Contract #: 04-0120F4Cty: SF/ALA Rte: 80 PM: 13.2/13.9File #: 69.25B**QUALITY ASSURANCE -- NON-CONFORMANCE REPORT****Location:** Changxing Island, Shanghai, P.R. China**Report No:** NCR-000509**Prime Contractor:** American Bridge/Fluor Enterprises, a JV**Date:** 16-Nov-2009**Submitting Contractor:** Zhenhua Port Machinery Company, Ltd (ZPMC), Changxing Island**NCR #:** ZPMC-0482**Type of problem:****Welding****Concrete****Other****Welding****Curing****Procedural****Bridge No:** 34-0006**Joint fit-up****Coating****Other****Component:** Segment 6AW, OBG Upper Floor Beam Flange**Procedural****Procedural****Description:****Reference Description:** Heat Straightening performed without Engineer's Approval in Segment 6AW PP38**Description of Non-Conformance:**

To:	AMERICAN BRIDGE/FLUOR, A JV 375 BURMA ROAD OAKLAND CA 95607	Date:	11-Dec-2009
Dear:	Mr. Charles Kanapicki	Contract No:	04-0120F4 04-SF-80-13.2 / 13.9
Attention:	Mr. Thomas Nilsson Project/Fabrication Manager	Job Name:	SAS Superstructure
Subject:	NCR No. ZPMC-0482	Document No:	05.03.06-000472

Reference Description: Heat Straightening performed without Engineer's Approval in Segment 6AW PP38

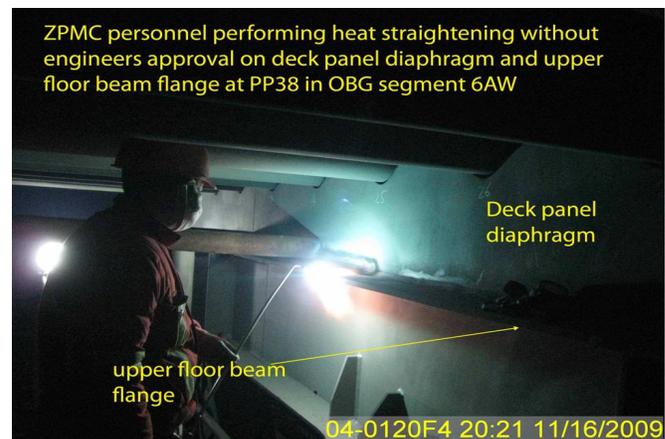
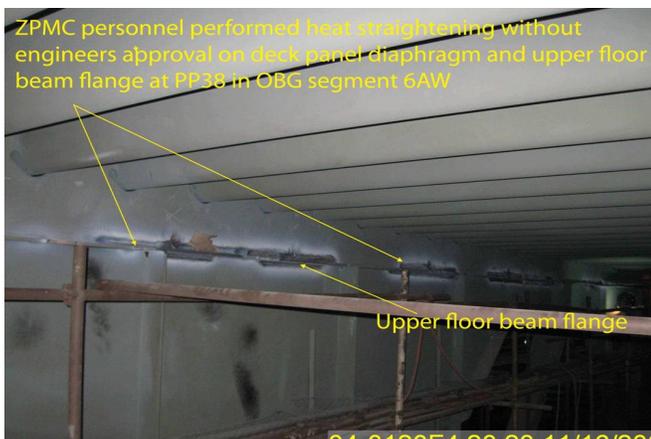
During random visual inspection this Caltrans Quality Assurance (QA) Inspector observed that ZPMC personnel were performing heat straightening on various locations on deck panel diaphragm and the upper floor beam flange in OBG segment 6AW at panel point 38. ZPMC QC or CWI were not present during the time of heat straightening. The non-conforming issues were noted:

1. No prior approval of the Engineer for the Heat Straightening Record. The maximum distortion noted on the flange is 20mm over the width of 170mm along the flange.
2. The heat straightening work performed was deviated from the HSR1(B)-7886 approved internally by ZPMC.

-Contract Special Provisions, Section 8.3: "For material less than or equal to 16 mm thick, the Contractor shall not heat straighten members more than 6 in 1000 without prior approval of the Engineer."

-AWS D1.5/2002 Section 3.7.3; "Members distorted by welding shall be heat straightened by mechanical means or by carefully supervised application of a limited amount of localized heat as approved by the engineer."

Obtain prior approval from the engineer before performing the work using an approved HSR. Submit a repair procedure to the engineer for approval.

Component: Segment 6AW, OBG Upper Floor Beam Flange

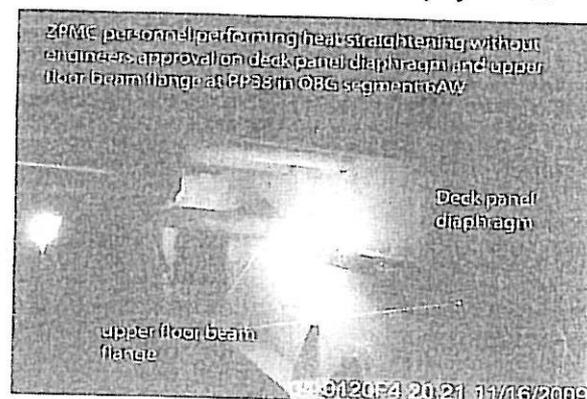
During random visual inspection this Caltrans Quality Assurance (QA) Inspector observed that ZPMC personnel were performing heat straightening on various locations on deck panel diaphragm and the upper floor beam flange in OBG segment 6AW at panel point 38. ZPMC QC or CWI were not present during the time of heat straightening. The non-conforming issues were noted:

1. No prior approval of the Engineer for the Heat Straightening Record. The maximum distortion noted on the flange is 20mm over the width of 170mm along the flange.
2. The heat straightening work performed was deviated from the HSR1(B)-7886 approved internally by ZPMC.

-Contract Special Provisions, Section 8.3: "For material less than or equal to 16 mm thick, the Contractor shall not heat straighten members more than 6 in 1000 without prior approval of the Engineer."

-AWS D1.5/2002 Section 3.7.3; "Members distorted by welding shall be heat straightened by mechanical means or by carefully supervised application of a limited amount of localized heat as approved by the engineer."

Contractor has supplied NDT documentation verifying the affected floorbeam welds are in conformance with Contract specifications. Additional reinforcing and NDT of deck panel welds will be addressed in Oakland in conformance with RFI2083.

简图 Sketch

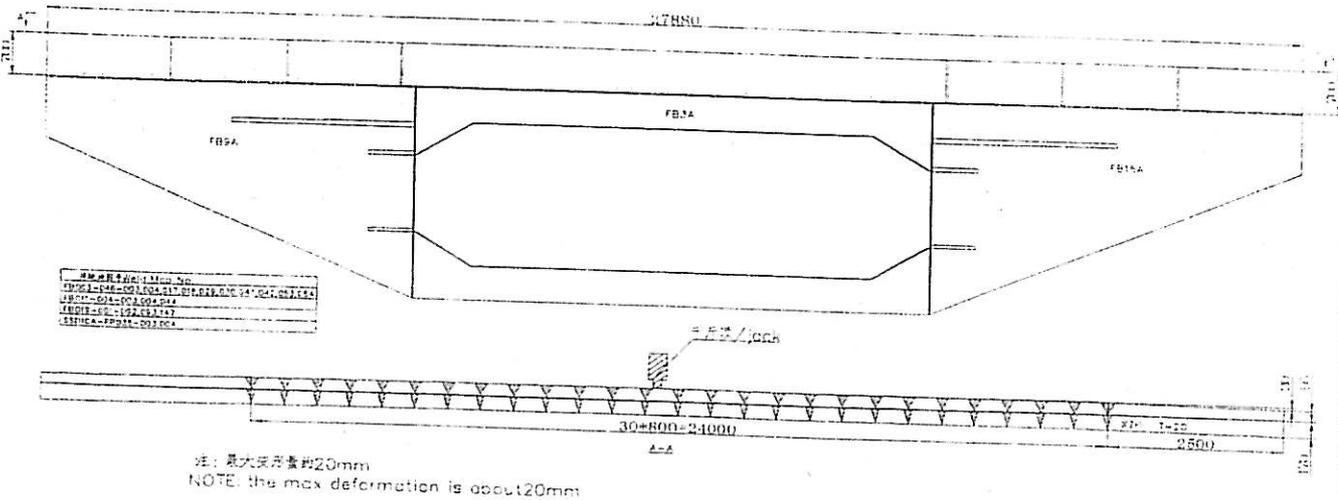
After finishing heat straightening, the weld of the heat area shall perform NDT according to the approved shop drawing 校火后, 根据图纸要求对热影响区域进行NDT检测。

Control current, voltage and weld speed according to relevant WPS. If necessary anti-deformation or hold down device can be added 依据相应的WPS的要求控制电流, 电压和焊接速度, 如有必要, 可使用反变形设施进行校正。
